Section 16 Planning Application for Proposed Minor Relaxation of Plot Ratio Restriction for Permitted Flat Use (Proposed Amendments to an Approved Scheme with Minor Relaxation of Plot Ratio Restriction under Application No. A/H6/91) at 4, 4A, 4B and 4C Tai Hang Road, Hong Kong (Application No. A/H6/97)

Responses to Departmental Comments

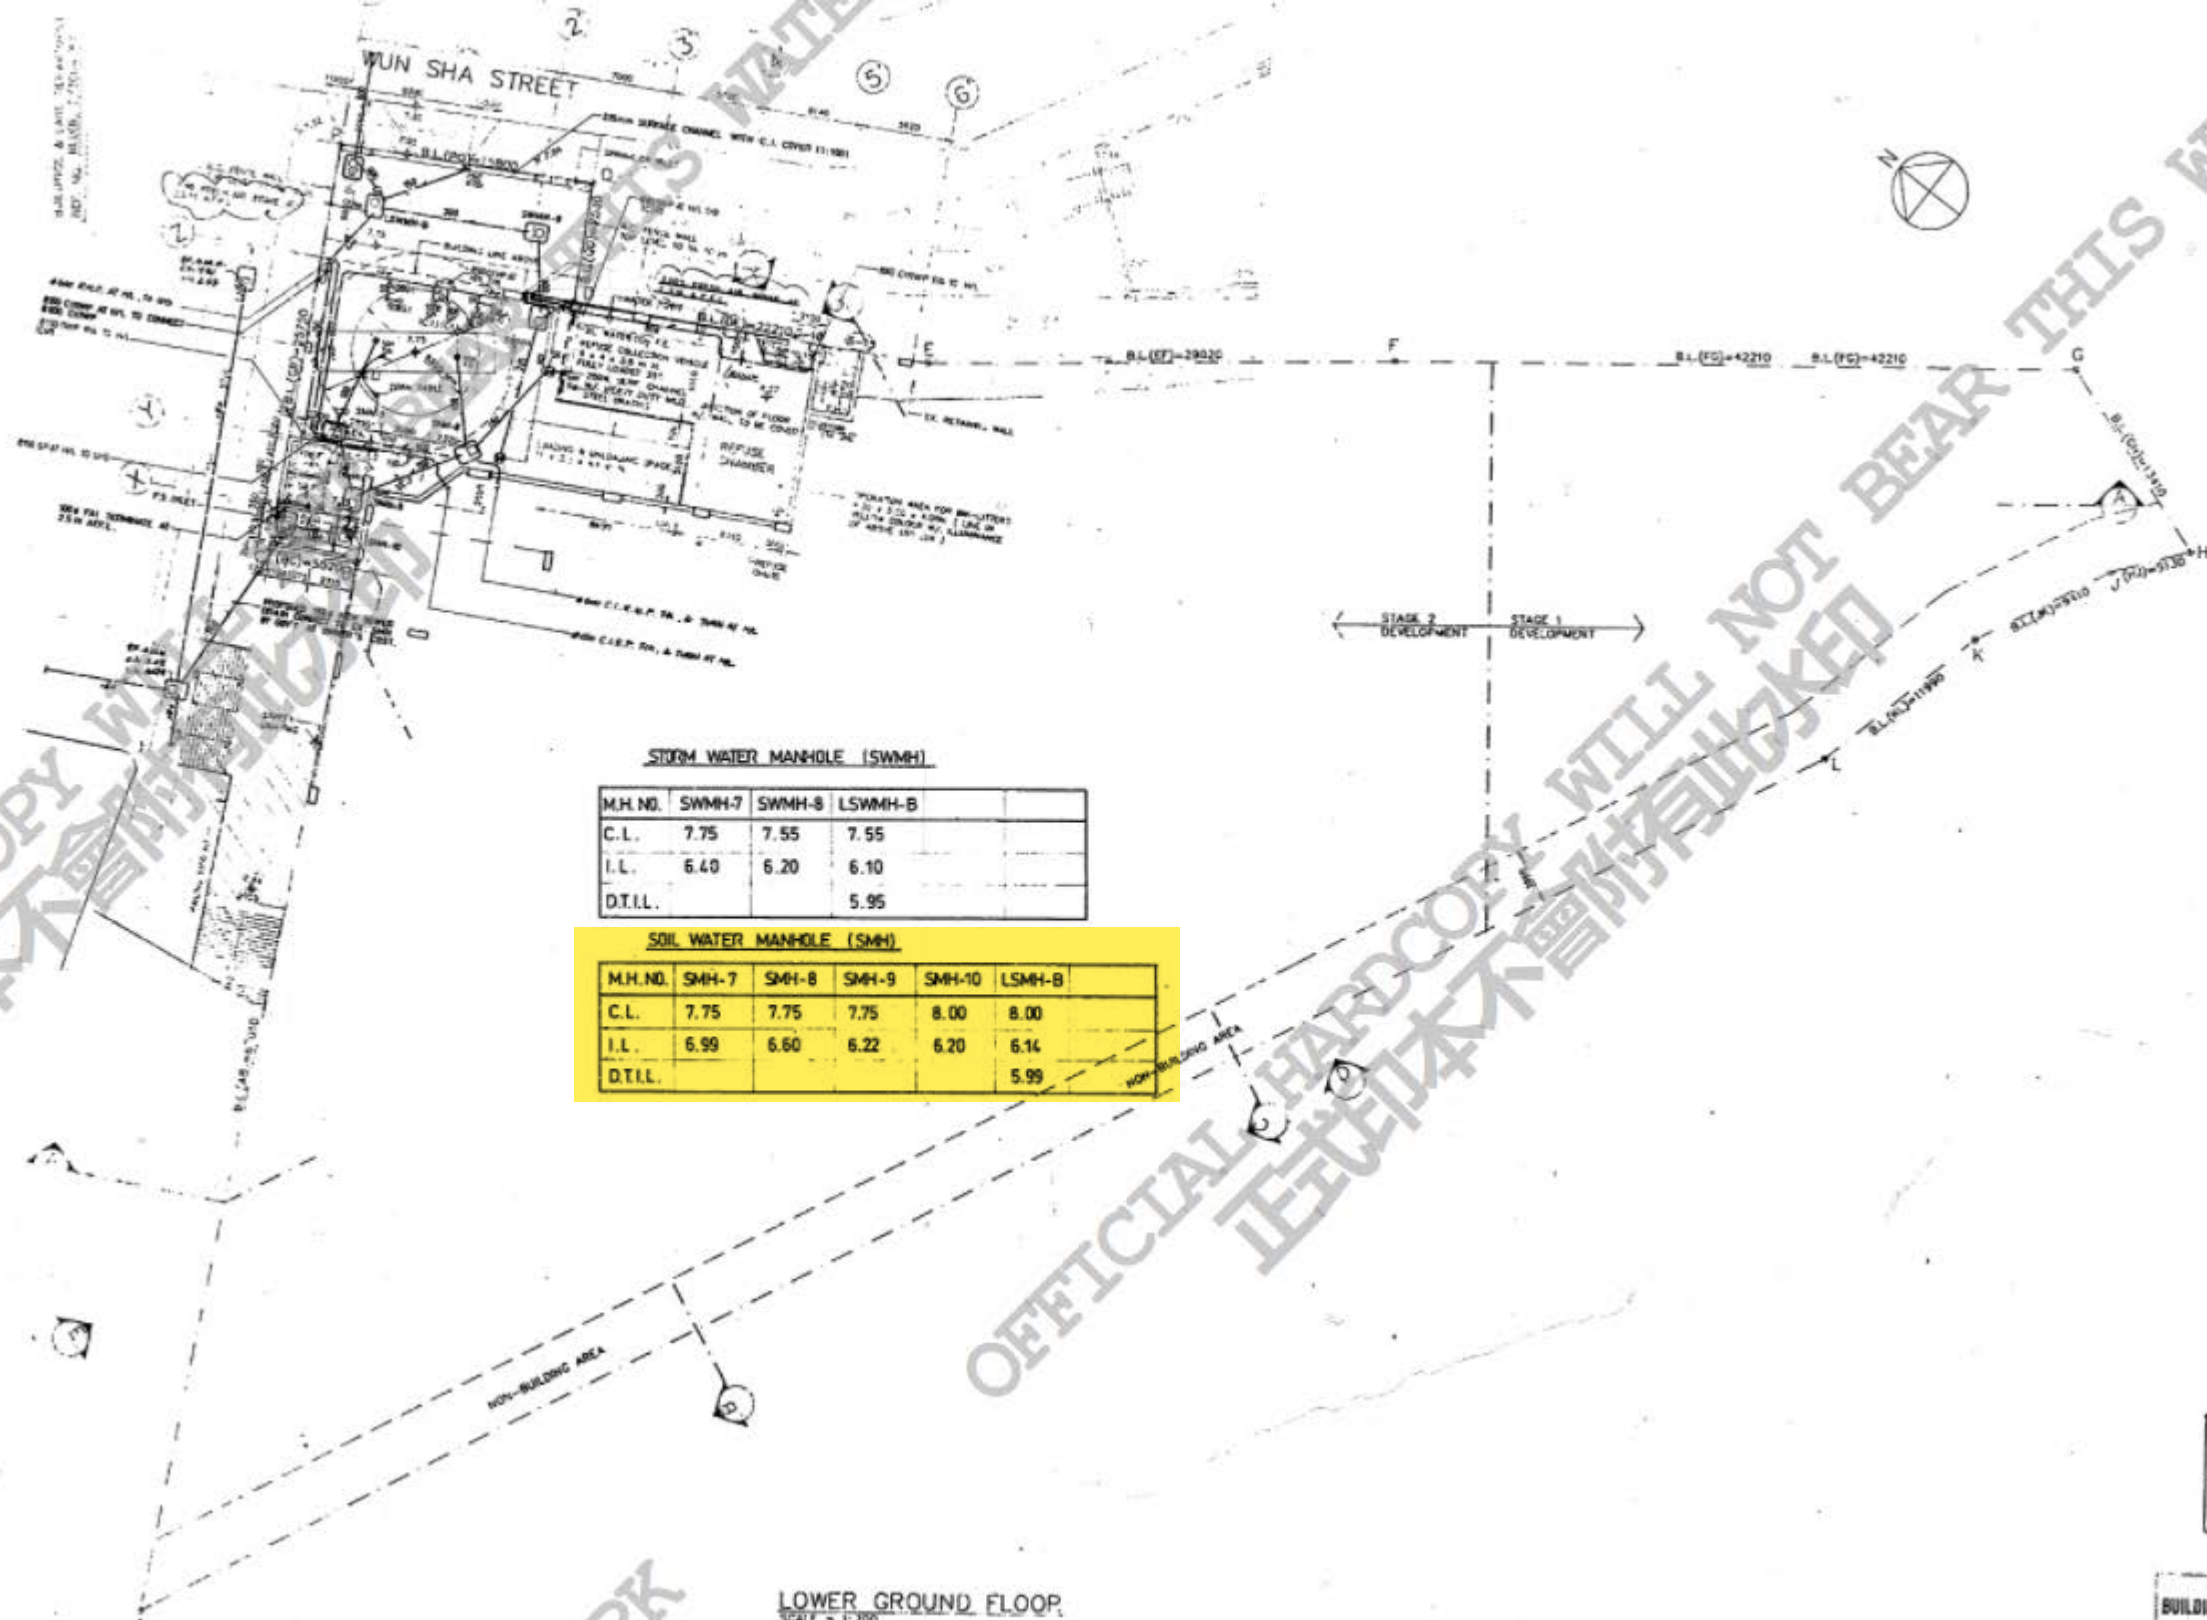
5.5	It is noted that a natural terrain hazard study for the “natural slope” above the proposed development was completed and mitigation measures have been proposed. Please ask the applicant to provide the latest information regarding the “natural slope” in the Geotechnical Statement.	The Natural Terrain concerned is located at the southwest of the site and between Trafalgar Court and Feature No. 11SE-A/CR109. The area ranges from +55mPD to +75mPD near Tai Hang Road. The natural terrain hazard assessment was conducted and existing conditions cannot meet the current slope safety standard. Installation of soil nails and provision of surface channel will be conducted as the natural terrain hazard mitigation measure to meet the current slope safety standard.
